CS-1 Dec. 1978 **OCT. 20. 1978**

CHANGING RESISTANCE VALUE

serial no. 7700 and higher.

ET-30B (151-030B)

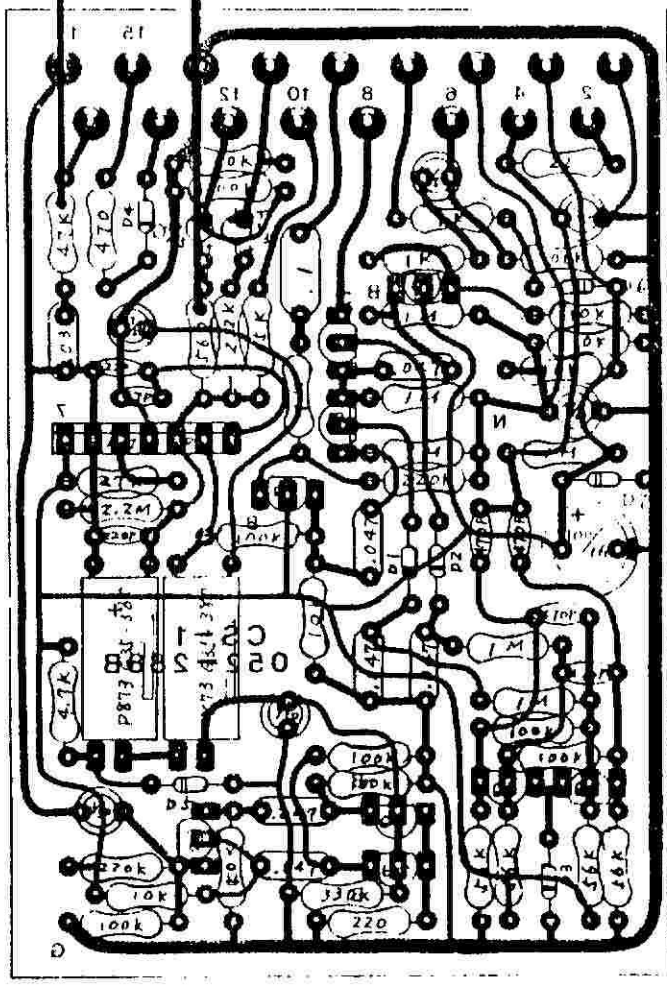
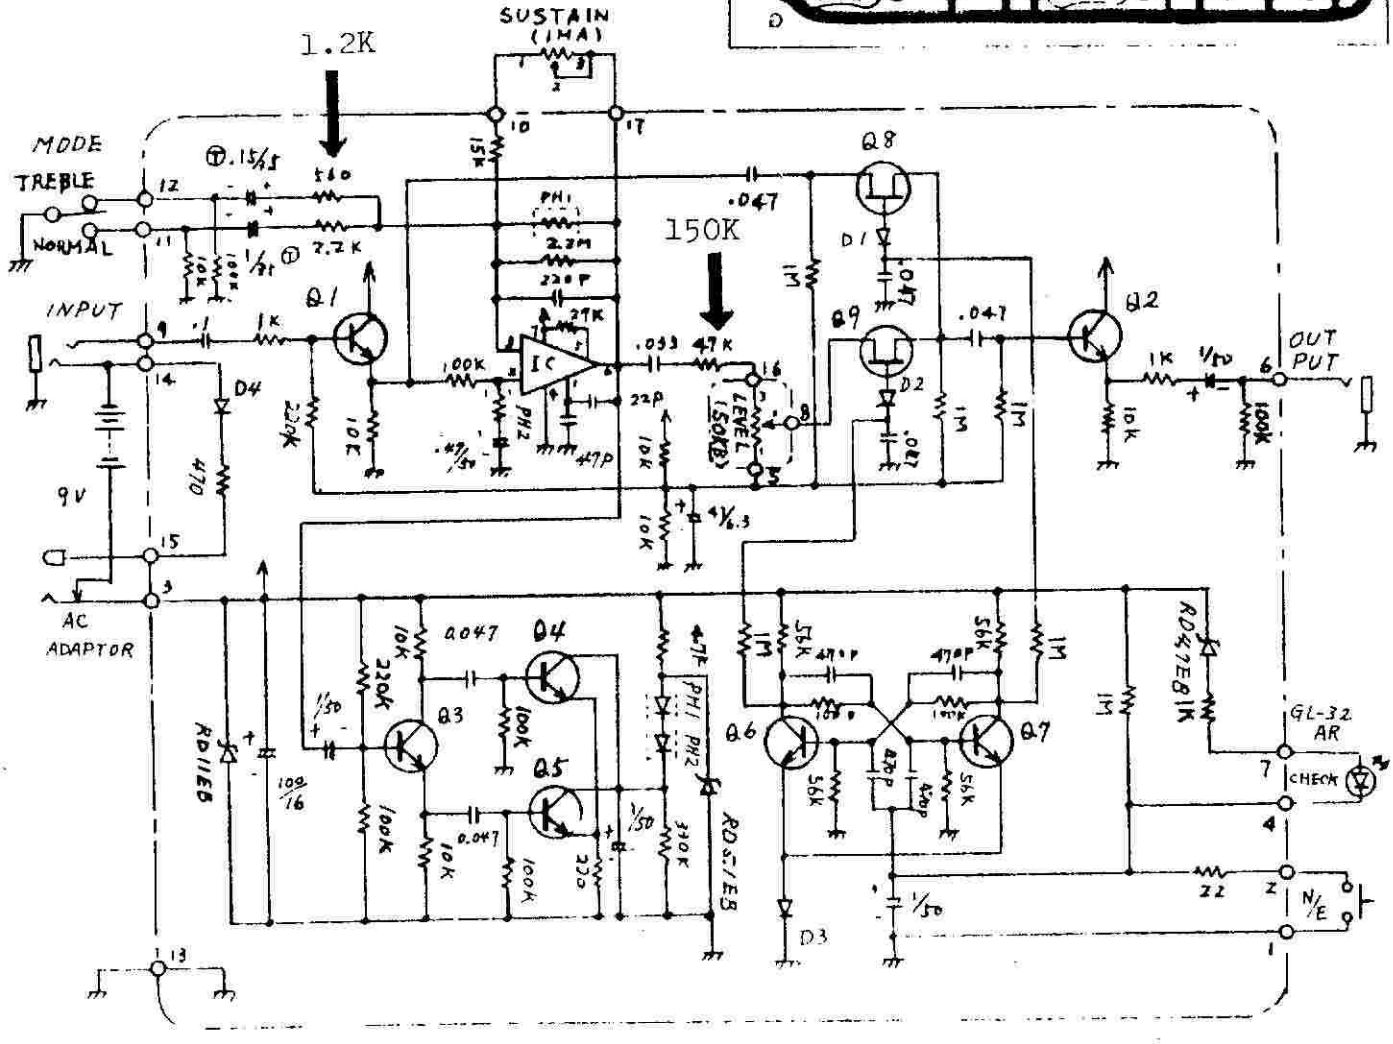
[illegible]-ohm → 1.2K 47K → 150K

1. For convenient vol. balance between DIRECT and EFFECT sounds.(can be balanced around center of rotation)
2. For reducing noise in TREBLE MODE.
3. Consequently, numbers in OUTPUT level are changed:

1.2K 150K

SUS-TAIN	INPUT Signal		OUTPUT Level	
	Sine		Mode NORMAL	Mode TREBLE
Max	1kHz	+10dBm	less than -10dBm	-10dBm
		0dBm	-15dBm	-15dBm
		-20dBm	-17dBm	-17dBm
		-40dBm	-18dBm	-18dBm
Min		-40dBm	-36dBm	-33dBm
Max	100Hz	-55dBm	-23dBm	-30dBm
Max	2kHz	-55dBm	-26dBm	-21dBm

acceptable tolerance ±3dB
